I last wrote to you in July, about some changes to our process and it is opportune to provide you with an update of the compliance audit process, labelling requirements, the introduction of new Kiosk substations to Powercor and letter of consent.

### 3. Kiosk Substations

Powercor have introduced new standards for Kiosk substations. The following are some of the main changes for Kiosk substations for new installations. Full details can be found on the Powercor Intranet.

Figure 2 - Box Culvert Foundation System (200 to 2000kVA)

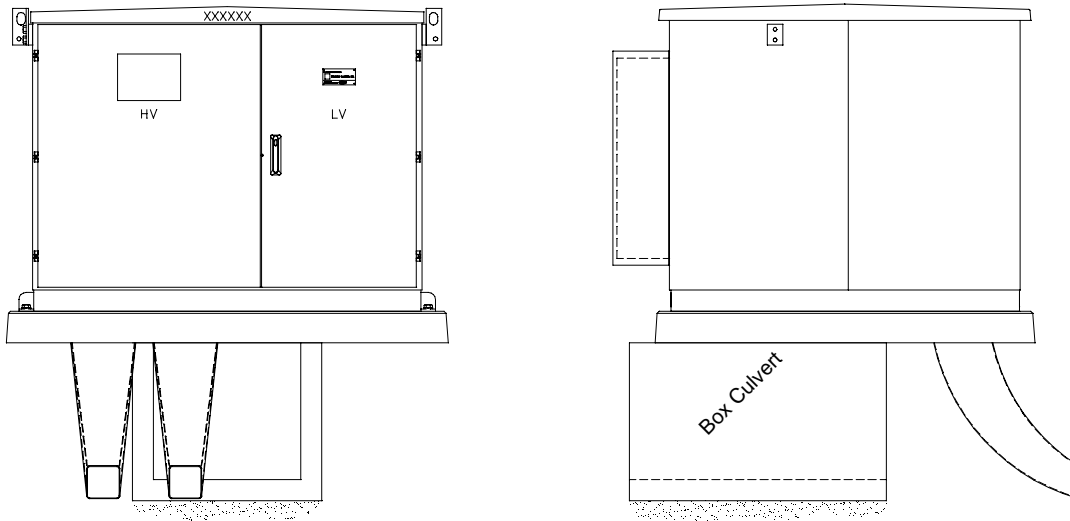
Powercor's standard range of kiosk transformers has both the HV and LV compartments accessible from the front, ie. side by side as shown in Figure 1. The front elevation and box culvert foundation is shown in Figure 2

For 200 kVA kiosk substations and above the HV compartment is on the left side when looking at the front of the kiosk, with the LV compartment on the right. For smaller substations of 100 kVA and below, the HV and LV compartment are combined.

Figure 3 - Kiosk Substation Reserve Size

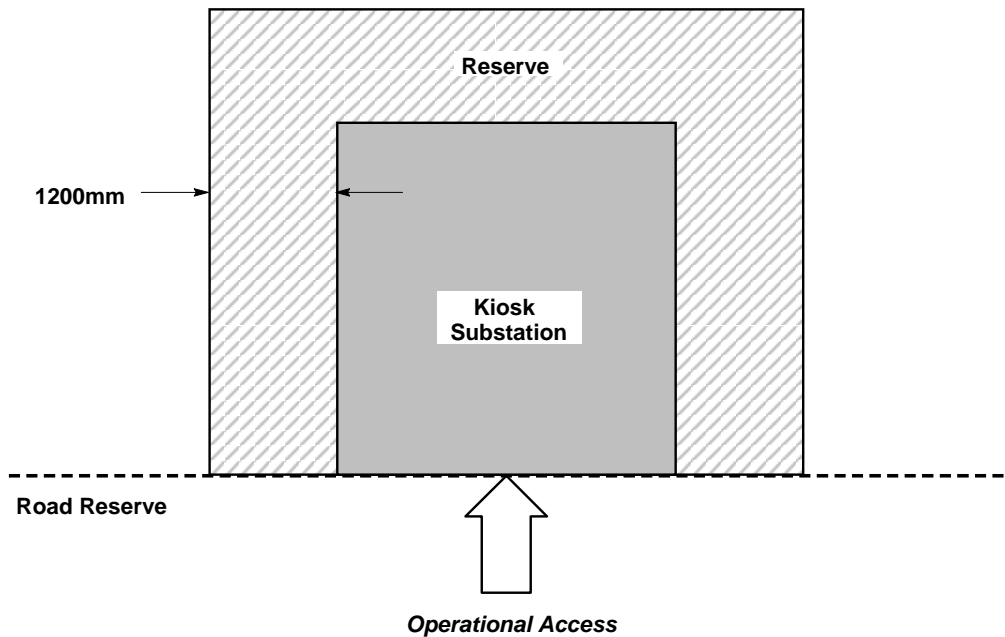
The front of the kiosk should be located at the road reserve, as shown in Figure 3. The reserve required for the substation is the size of the kiosk and a 1.2m boundary surrounding the substation lot (as shown in Figure 3). These new requirements should be used to register the reserve on the plan of subdivision.

The approximate size of the reserve for full capacity substations is given in Table 4.
